Model	IBIS	Volt/Hz	Date of Modification	Serial Number
Modified Article	Parts Catalog			
Reason for Modification	Parts Catalog Correction

MODEL NAME	V/Hz	DESTINATION	CODE	SERIAL NUMBER
Gestetner 2615 Nashuatec 3415 Savin 9015	115/60	USA, Canada, L. America	A128 -10	
Savin 9015	115/60	USA, Canada	A128 -15	
Ricoh FT4215	115/60	USA, Canada	A128 -17	
Ricoh FT4215	110/60	Taiwan, etc.	A128 -19	
Gestetner 2615 Nashuatec 3415 Rex Rotaly 8615	220, 240/50	Europe, etc.	A128 -22	
Infotec 9315	220, 240/50	Europe	A128 -26	
Ricoh FT4215	220, 240/50	Europe	A128 -27	
Ricoh FT4215	220/60	Saudi Arabia	A128 -28	
Ricoh FT4215	220/50	Asia, etc.	A128 -29	
Nashuatec 3415	110/60	Taiwan	A128 -39	
Aurora AC4515	110/60	Taiwan	A128 -99

MODIFICATION BULLETIN

Model: IBIS	Date: 15-Feb-97	No: 25	1/3
Modified Article: Parts Catalog		Prepared by: Inohana	
From: 1st Technical Support Section		Checked by: T. Inoue

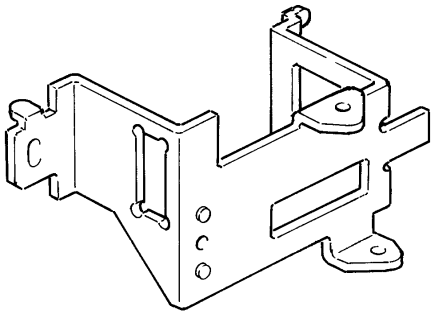
1. The main switch has been changed to a rocker switch.

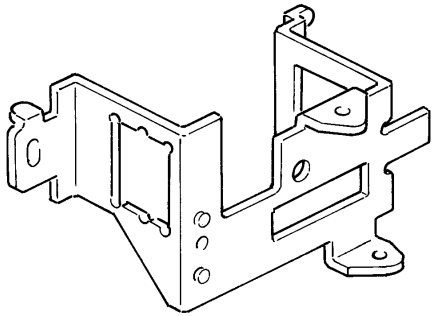
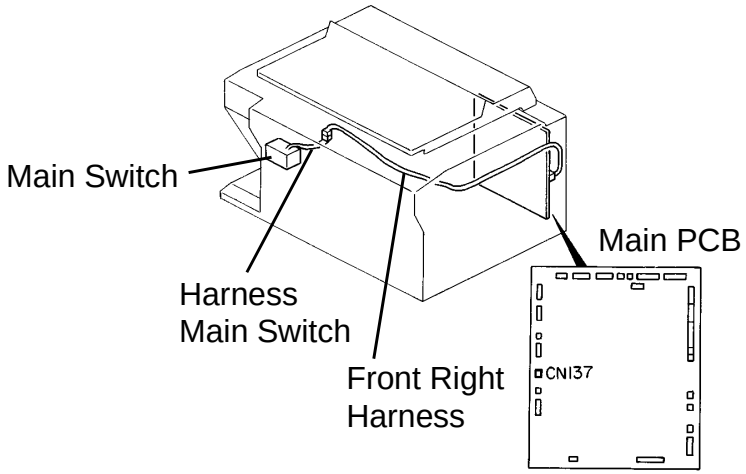
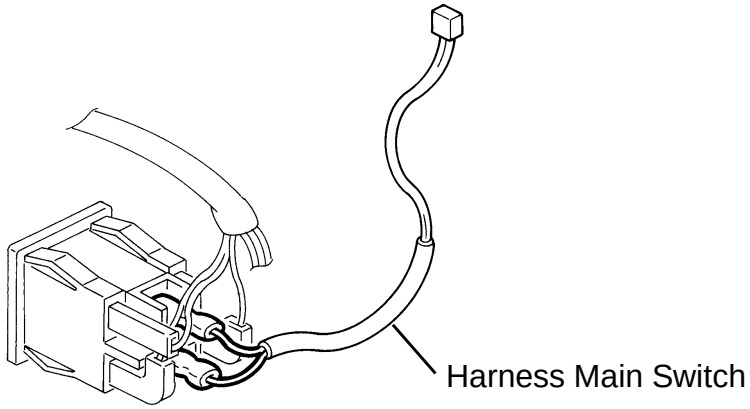
2. The safety switch bracket has been modified to incorporate the new main switch.

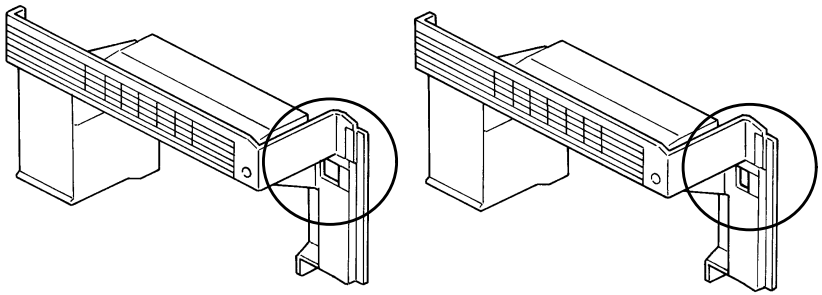
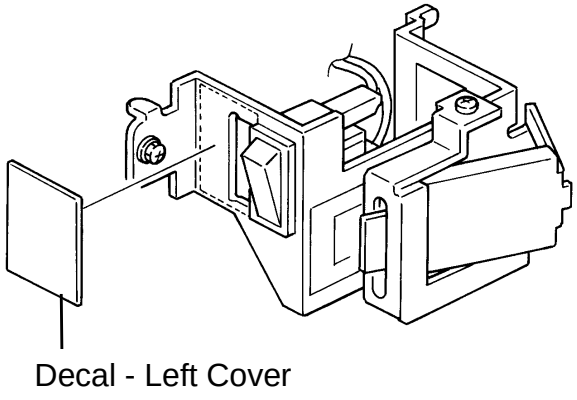
3. A Harness Main Switch has been added and the Front Right Harness has been modified to provide signals from the Main PCB to the main switch.

4. The opening for the main switch on the left cover has been enlarged to incorporate the new switch. For the machines without the Energy Star mark, (-19, -22, -26, -27, -28, -29, -39, -99), a left cover decal is added to cover the opening. When you use a new cover on an old machine, it is also necessary to add a left cover decal.

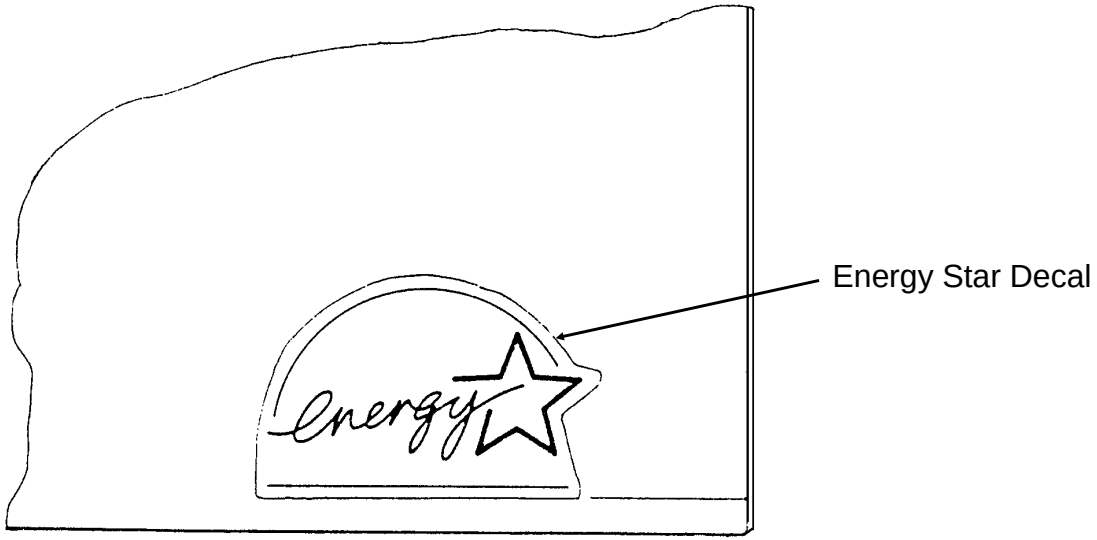
5. The Energy Star decal has been added on the bottom right corner of the front cover.

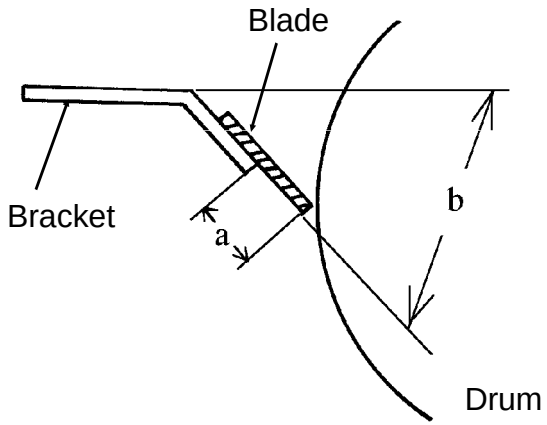
To improve cleaning, the cleaning blade has been modified as follows.

1) The length "a" in the drawing has been changed from 10 +0, -0.3mm to 9.5 ±0.3mm.

2) The angle "b" in the drawing has been changed from 70° ±2° to 67.5° +2° -1°.

3) The material of the blade has been changed. This modification is the countermeasure for the vertical and horizontal black line problem.

Old P/N	New P/N	Description	Q'ty Used	Inter-change-ability	Parts Catalog	
					Index No.	Page
A128 3552	A128 3562	Cleaning Blade	1	X/O	19	45
